MetroLink Railway Order Statutory Consultation

Section 5.2, Part 2 of 2 – TII Response to Submission
No.'s 141 to 320, plus Fingal County Council Submission

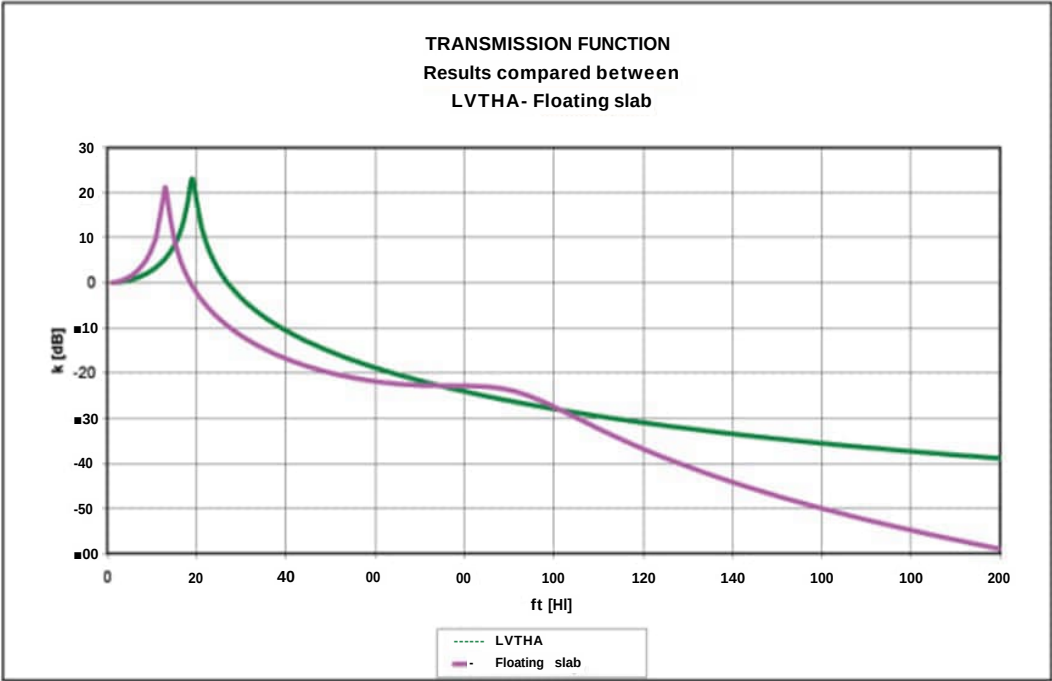
Submission No.			303	
Organisation Name or Name of Submitter			Trinity College Dublin	
Item No.	Section Ref.	Page No.	Observation Statement	TII Response
MetroLink - Railway (MetroLink - Estuary to Charlemont via Dublin Airport) Order 2022 Submission made on behalf of Trinity College Dublin ABP Ref.: NA29N.314724

System	Dimensions L x W [mm]	Total weight (single rail support)* [kg]	Preliminary global support stiffness** [MN/m]
LVT Standard	676 x 300	100	9
LVT High Attenuation	676 x 376	123	15
*Total weight= single concrete block + resilient components + standard fastening system			
**Preliminary global spring rate, incl. rail pad, rubber boot and block pad
